September 3, 2025

Residence at Carter Lake – New Senior Living Facility – JGR Proj 25-3489

ADDENDUM NO. 1

Sheet C3A

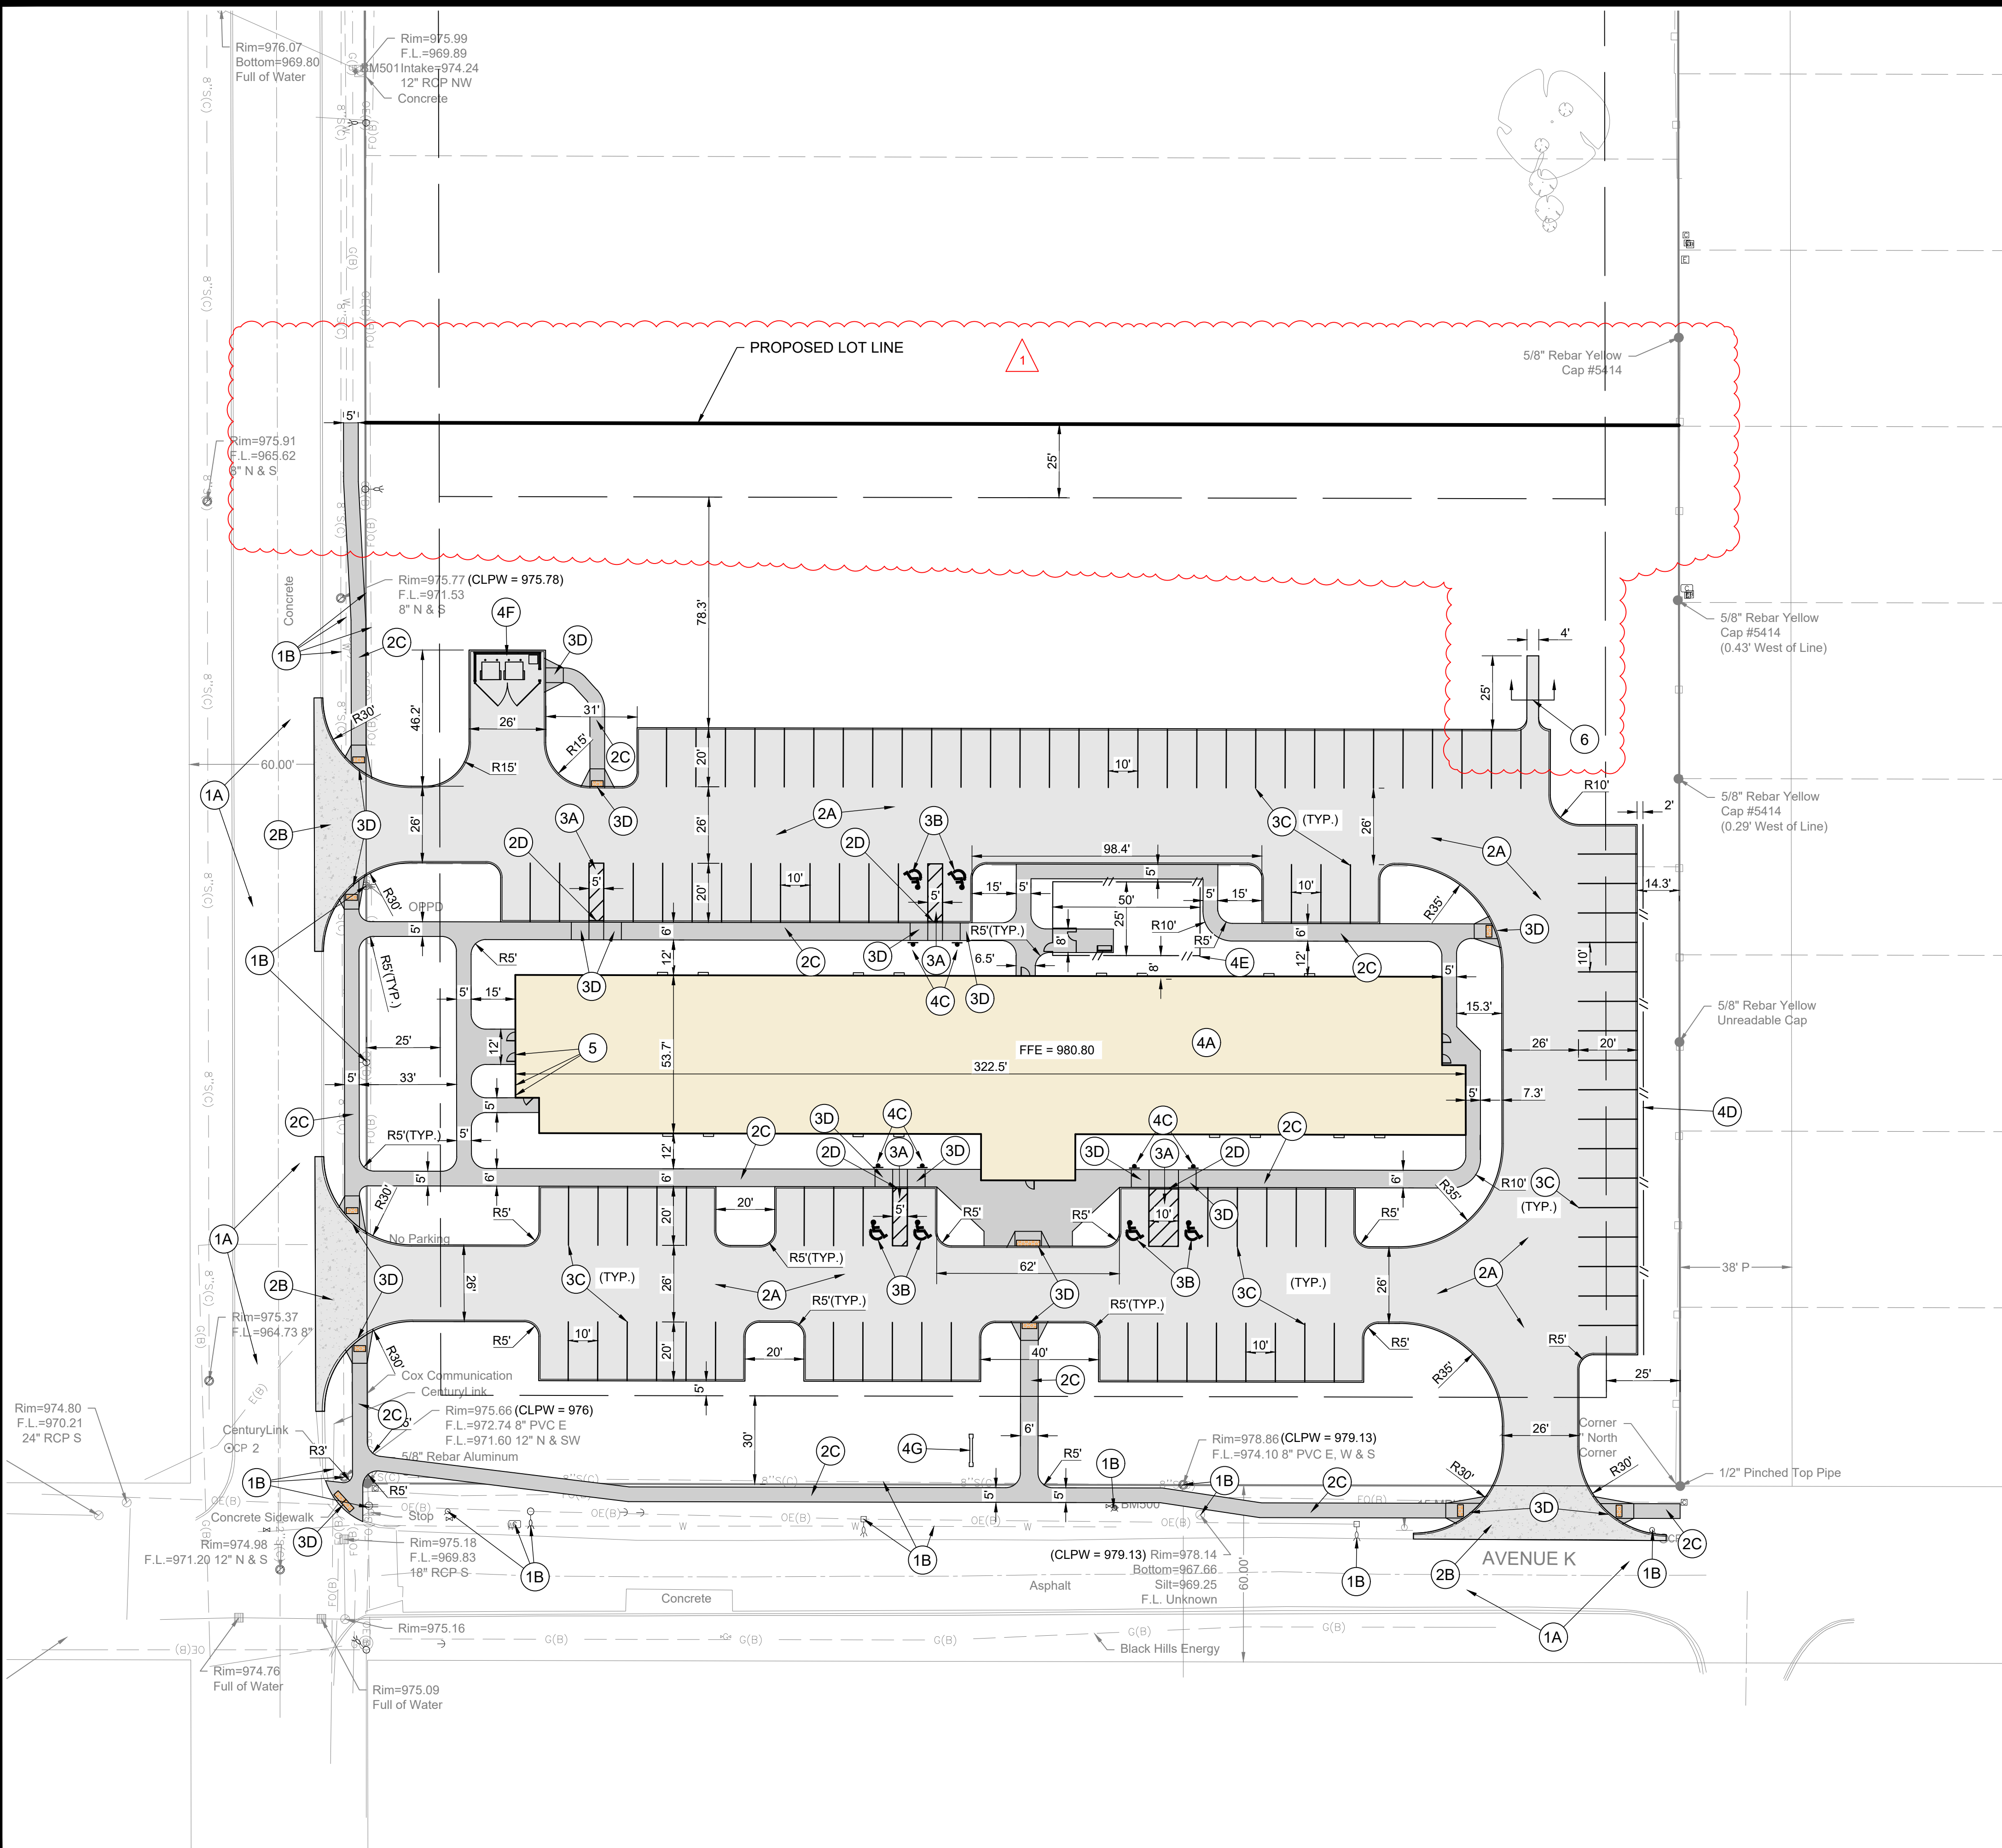
1. Sheet C3A – Property line split changed locations.
2. Sheet C4 – Property line split changed locations. NE corner of parking lot has a concrete flume added. Sidewalk changed to stop at new property line.

Sheet C5

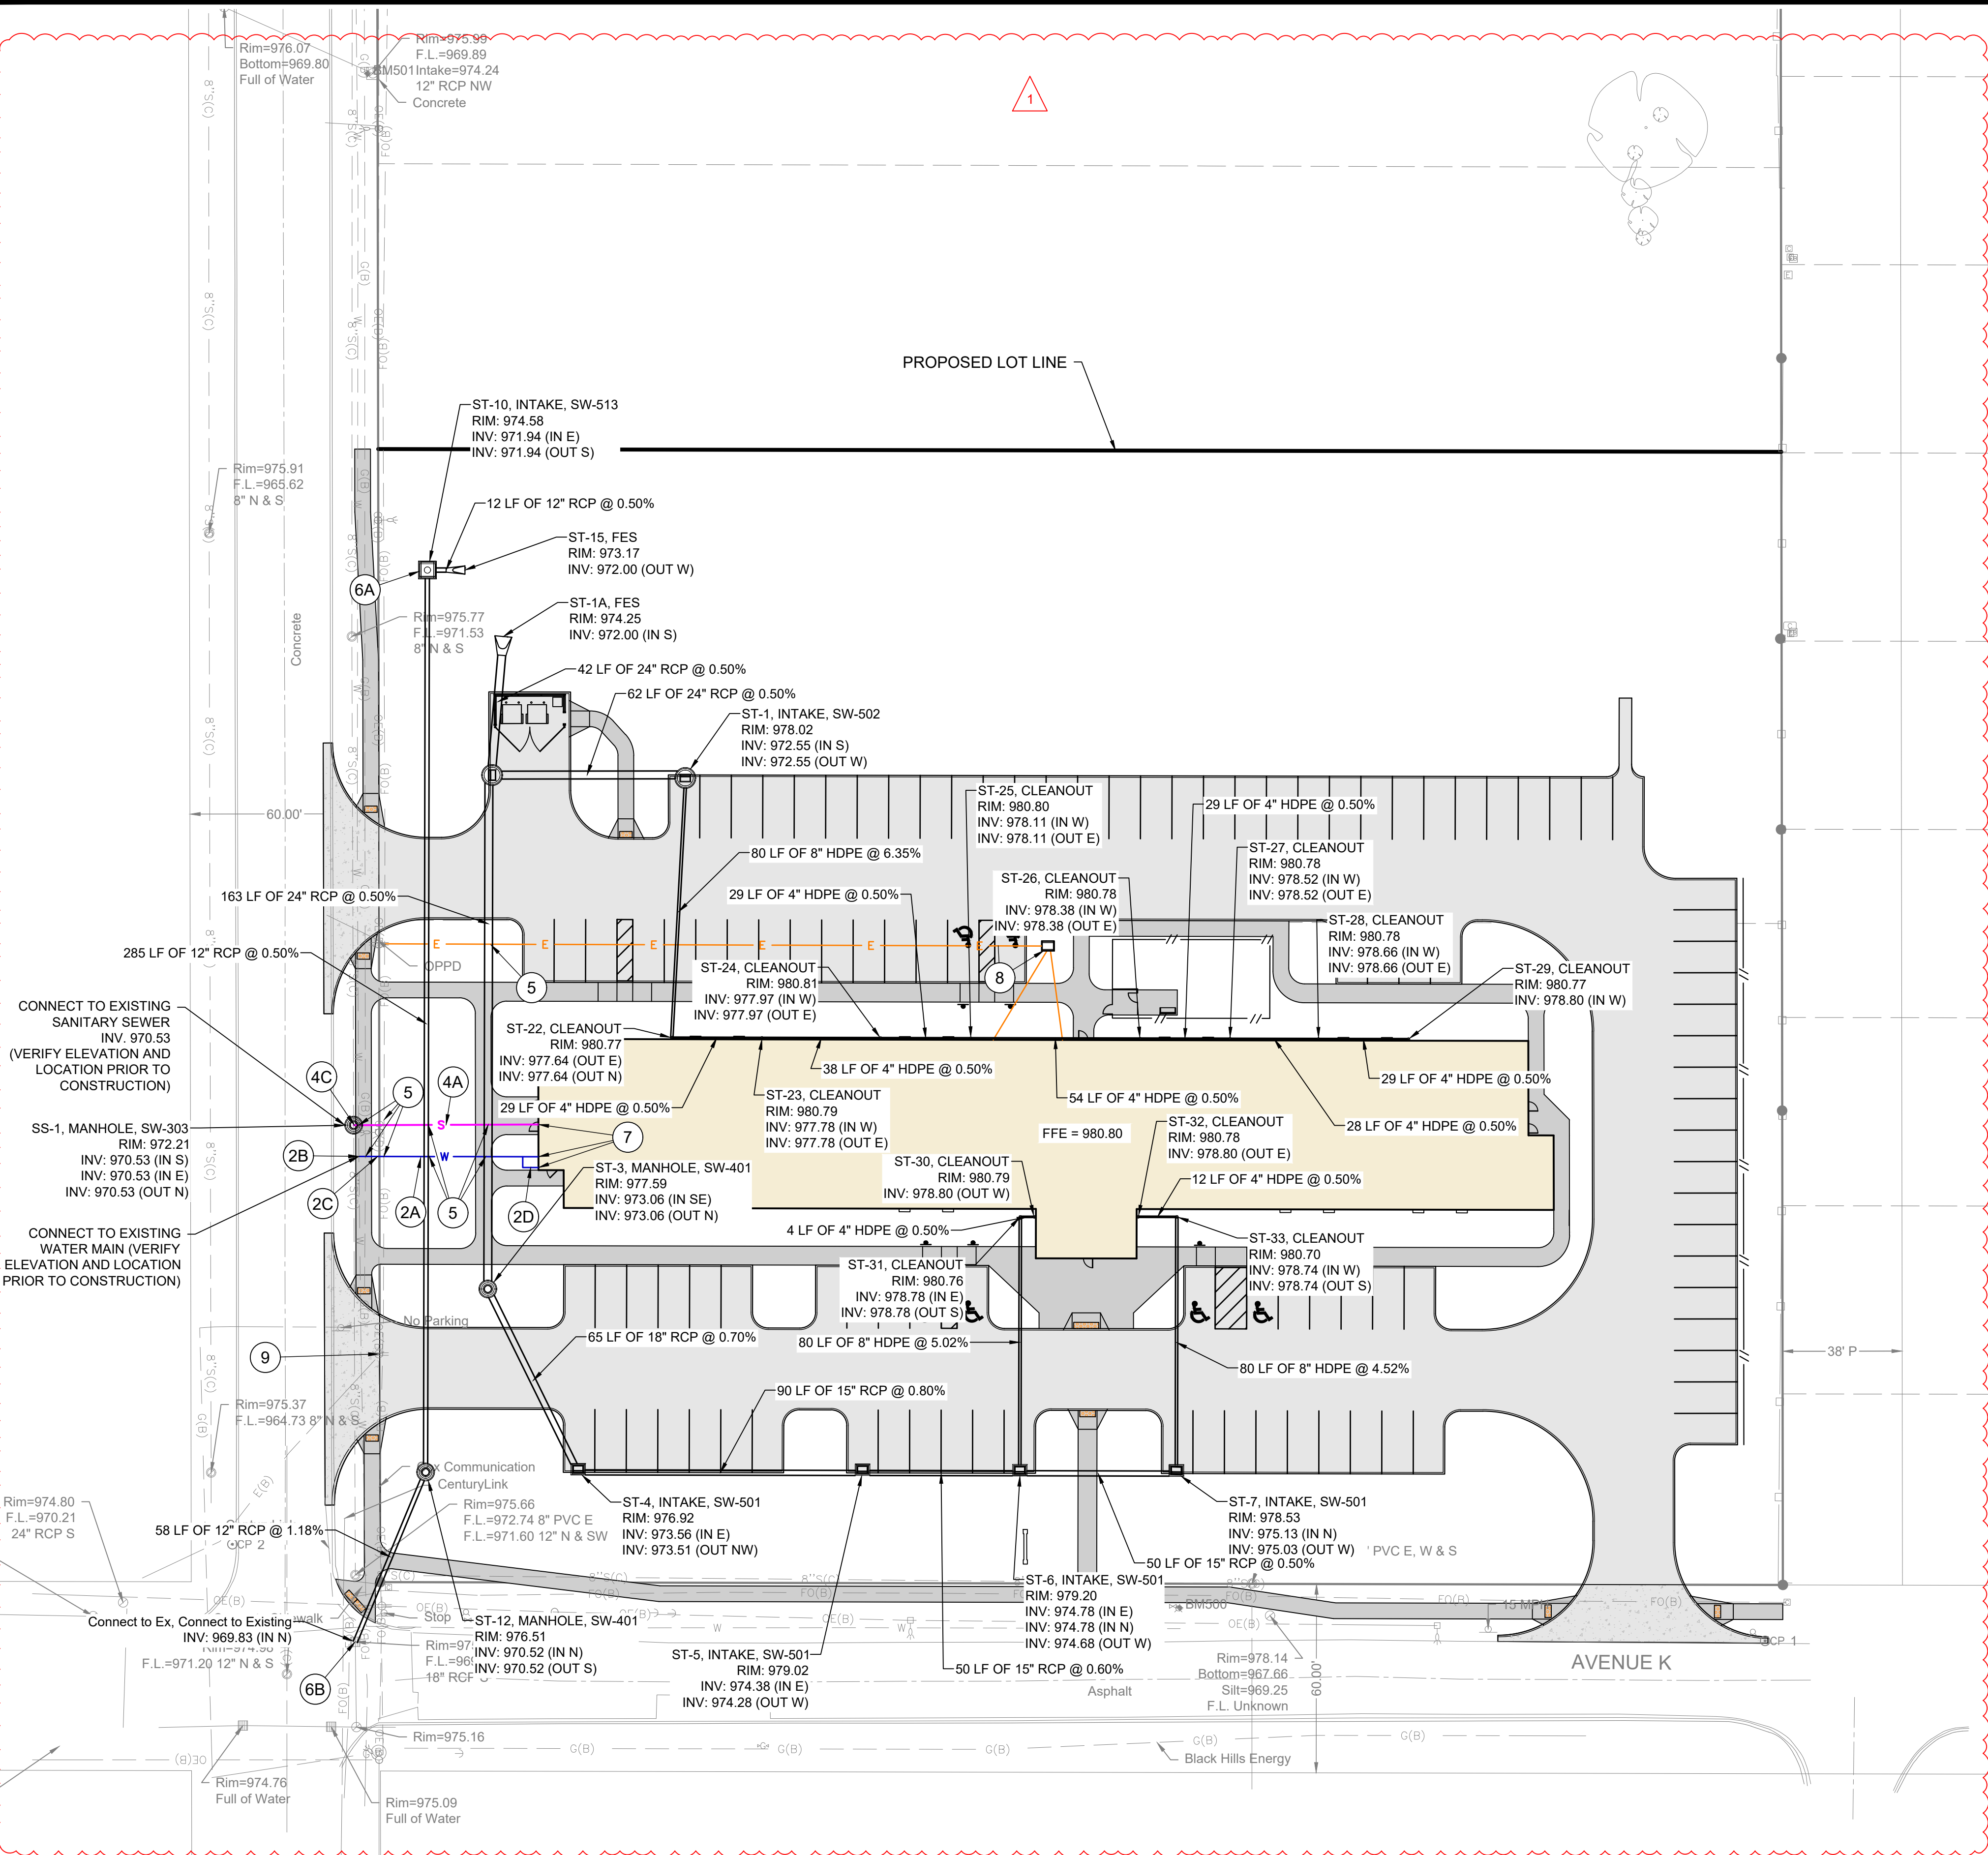
3. Sheet C5 – Roof drain storm pipe added along the north side of building & 2 locations on the south for the canopy. Inlet inverts updated to work with a more shallow pond. Pond outlet structure & piping updated to take water to the south, rather than the north. In the NE corner of parking lot storm was removed & changed to a concrete flume.

Sheet C8

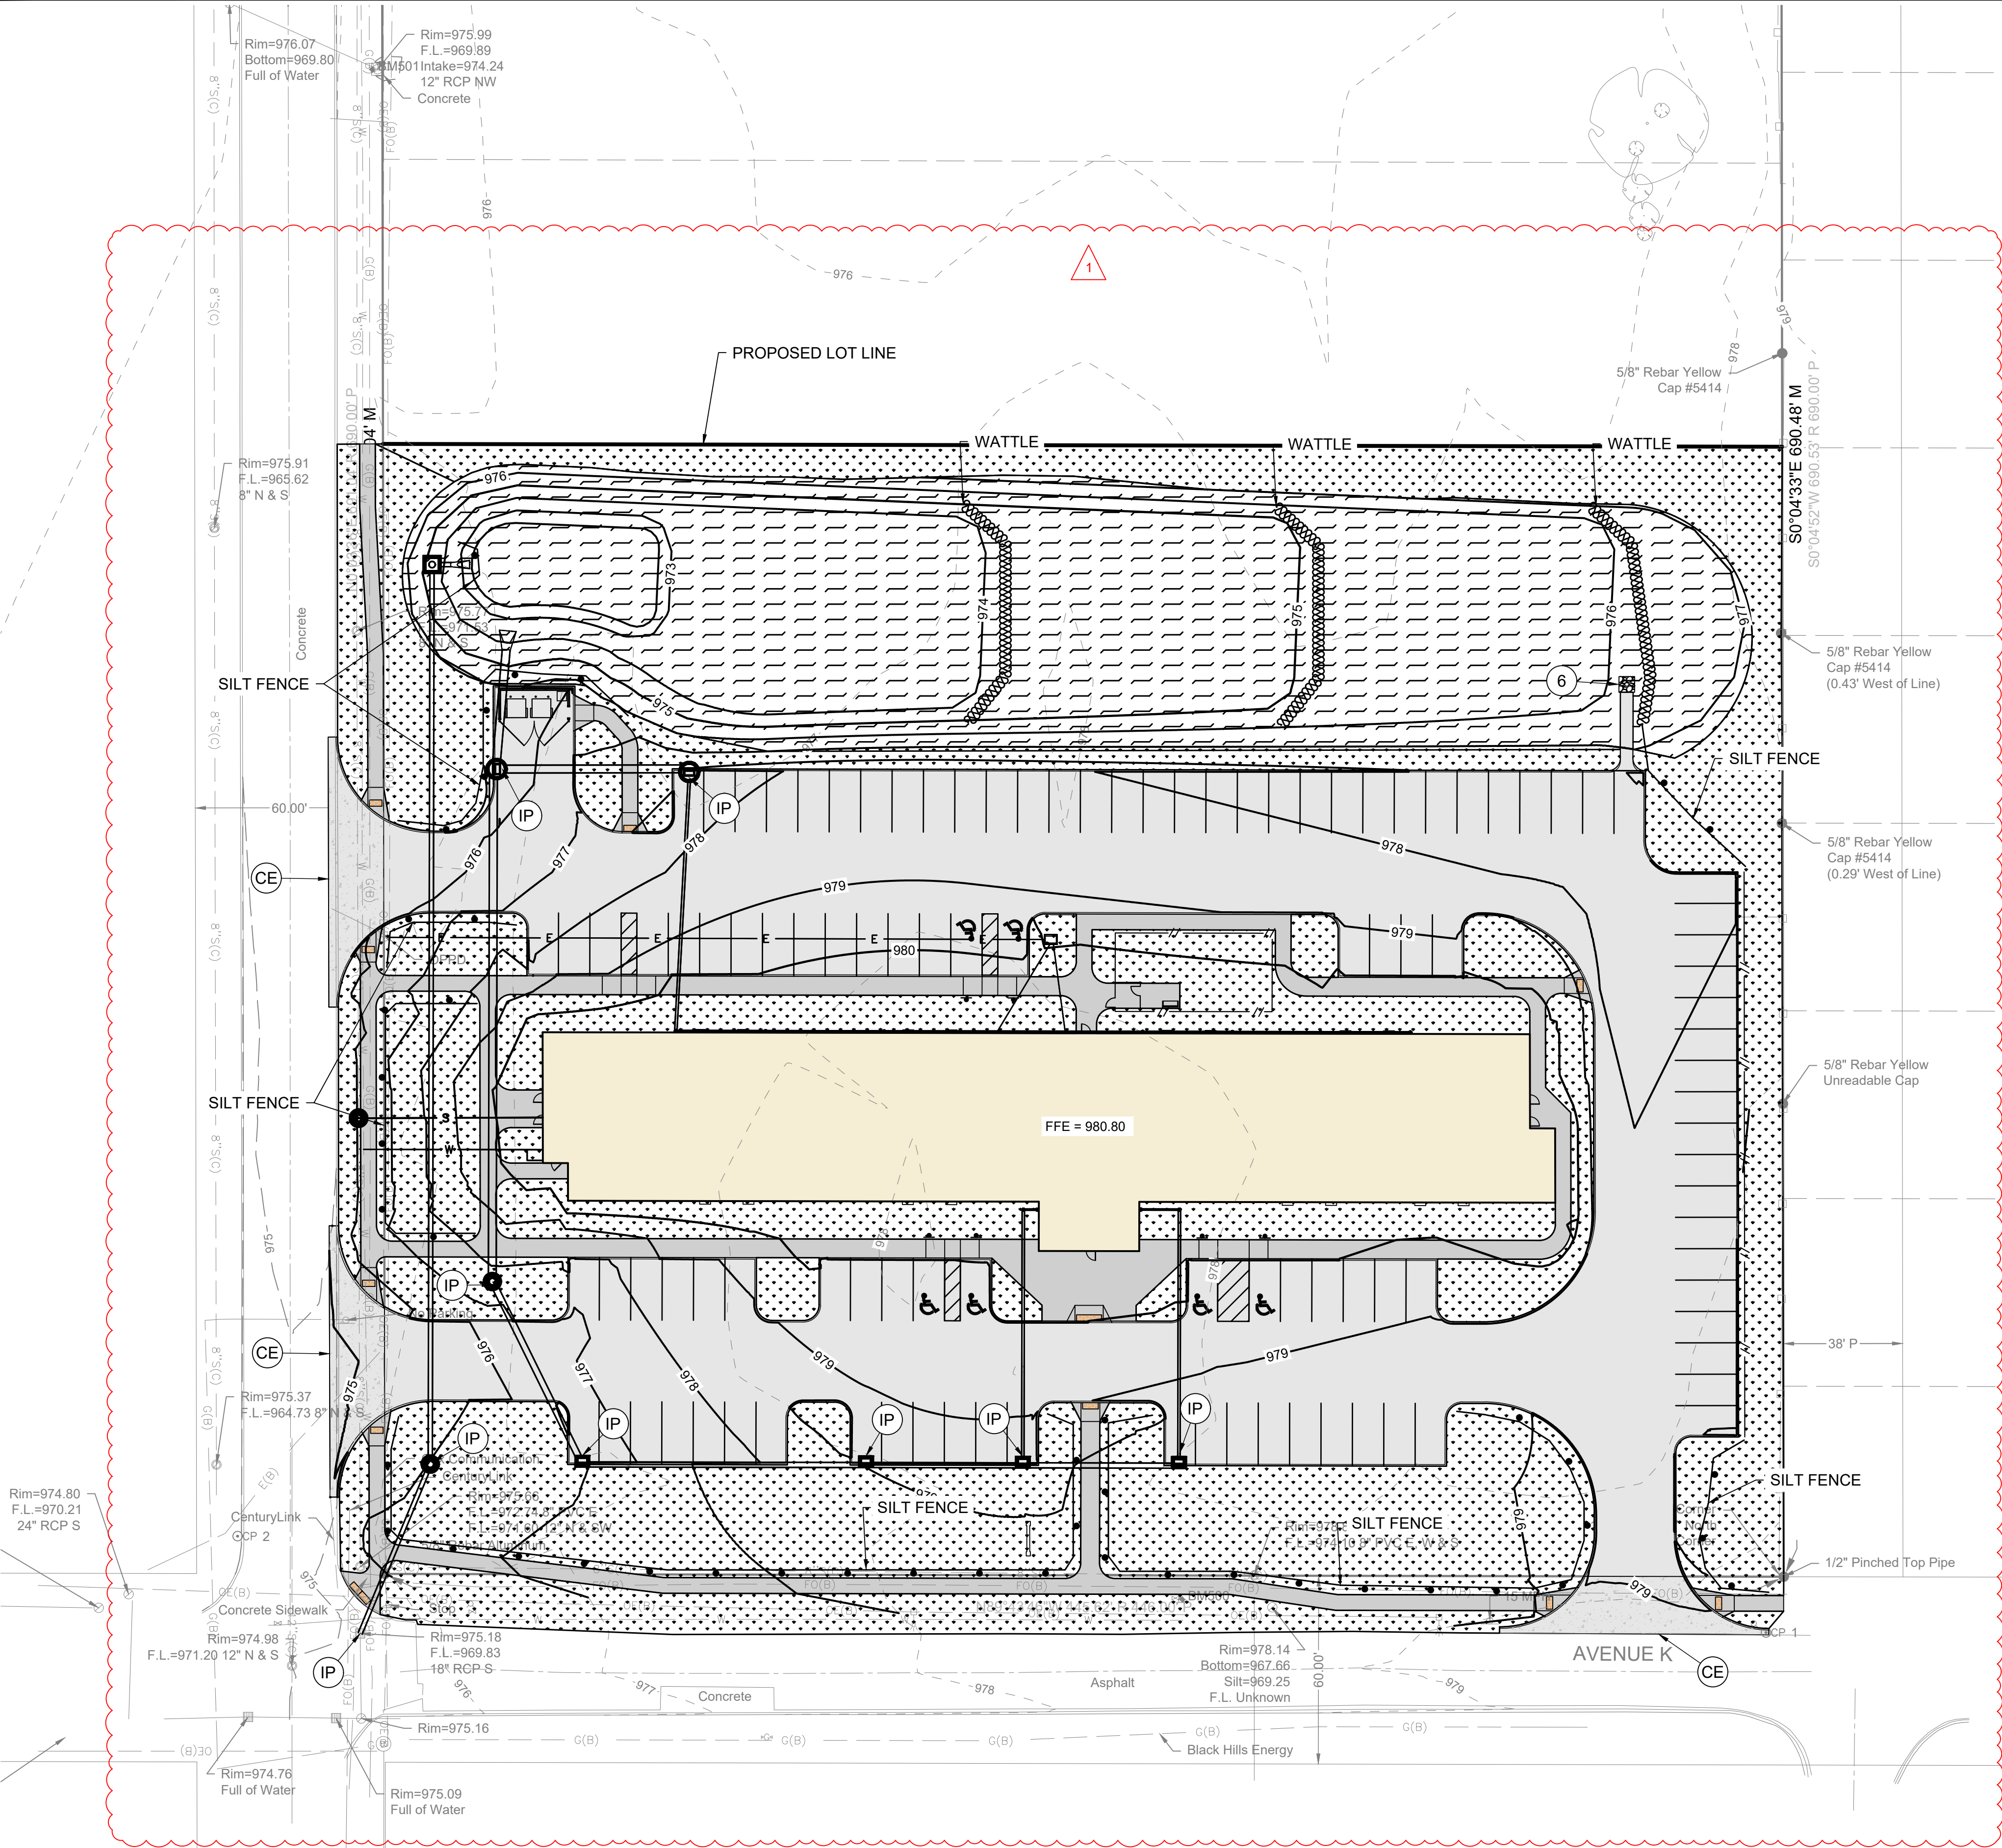
4. Sheet C6 - Grading changes along the east & in the north pond area to make pond larger, less steep & less deep.
5. Sheet C8 - Updates to the erosion control needs based on grading changes. Took seeding to the lot lines rather than the grading limits.
